# Comments on SAS2r14 Physical Layer

**Kevin Witt**

**March 11, 2008**

**08-144r0**

## ISI Insertion Loss Calibration

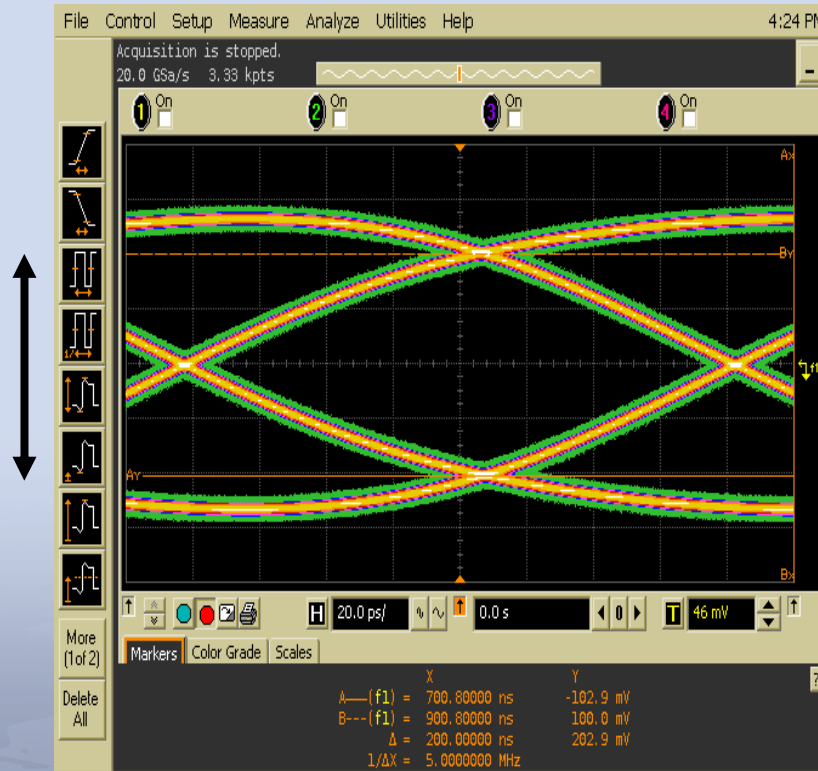
- Should we change the specification to the mean of the crossing to the mean of the crossing

180 → 220mV

Note: on a limited set of cable we saw a significant variation on insertion loss

## Summary of Proposed Calibration

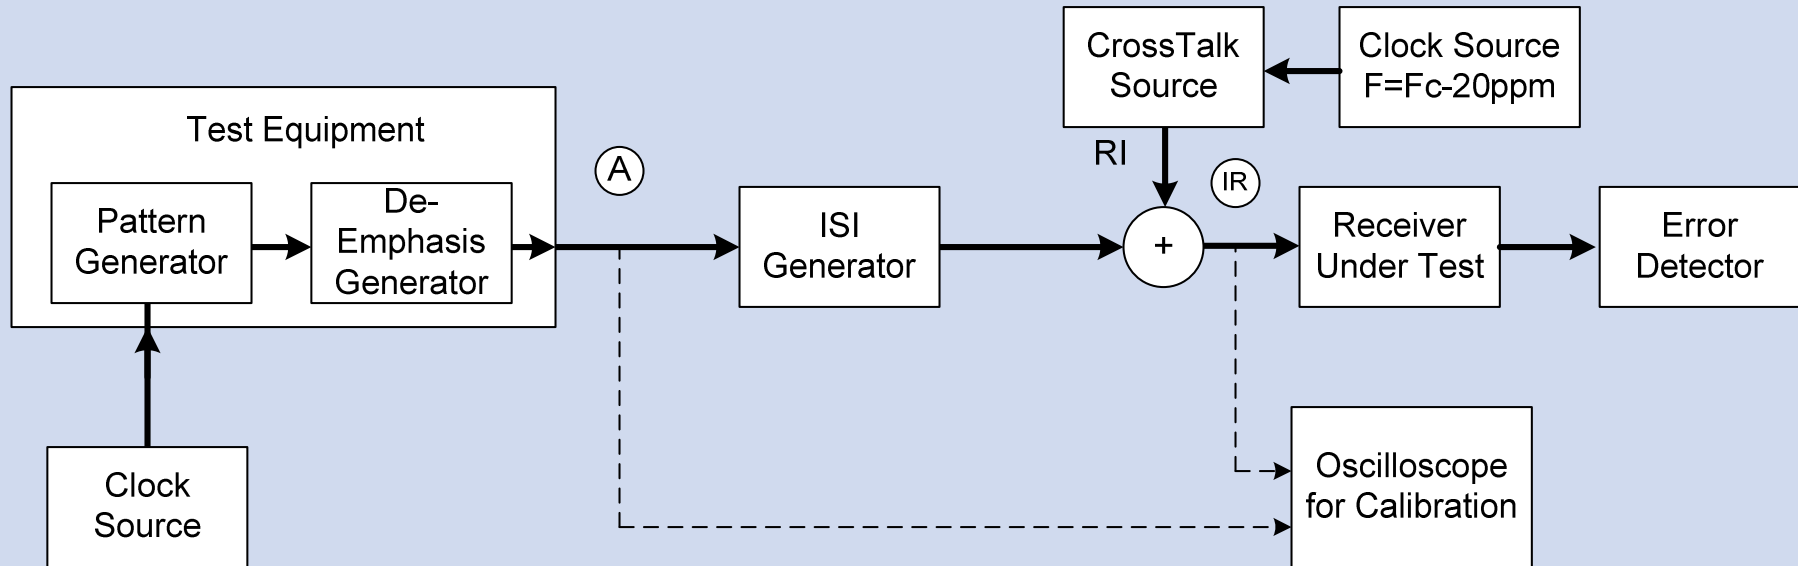
- 1. Transmitter Amplitude Setup and ISI Generator @ IR**
  - Use D24.3 Inner eye  $\sim 200\text{ mV}$
  - Compute  $\text{TxWDP} + \text{WDP} > 13\text{dB}$  of Delivered Signal
- 2. Transmitter Jitter Calibration @ A**
  - Adjust  $\text{RJ} = 0.15\text{ UI pk-pk}$
  - Adjust  $\text{BUJ} = 0.022\text{ UI pk-pk}$
- 3. Crosstalk @ IR**
  - PRBS-7 Crosstalk Source and Adjust Coupled Amplitude  $> 4\text{mV rms}$
- 4. Test – Confirm  $\text{BER} < 1\text{e-}12$**

## Calibration Procedure Illustrated

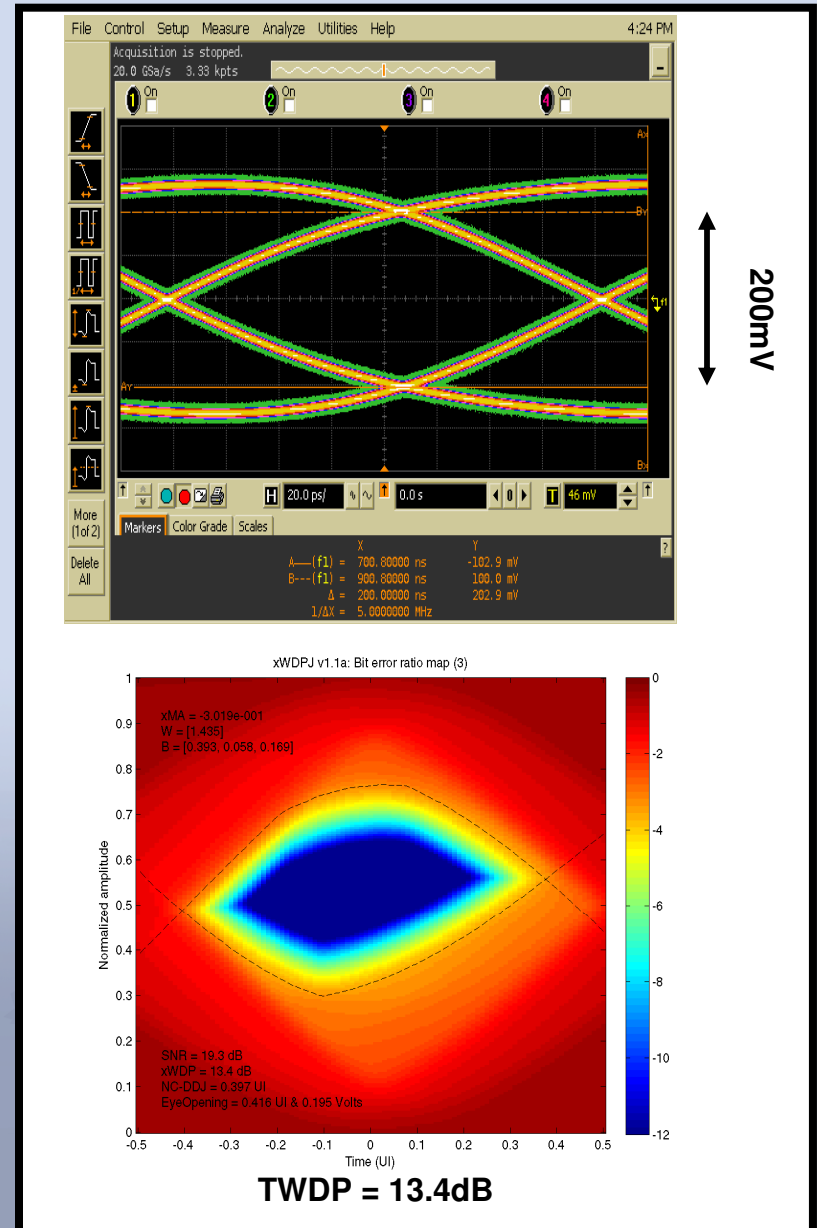
1. Measure Inner Eye with D24.3
  - Without jitter or Crosstalk
2. Compute WDP of Delivered Signal with SAS CJTPAT for the budgeted PALLOC of 15.4.
  - Make sure  $> 13.0$  dB
3. Setup Tx Jitter with Standard Test Equipment Options.
  - $RJ = 0.15UI$
  - $BUJ = 0.022UI$
4. Setup Additional Cross talk as needed to meet NEXT limit.
  - Turn on all channels, add crosstalk for a total of 4mV RMS
5. Confirm DUT BER  $< 1e-12$  @ 95% confidence
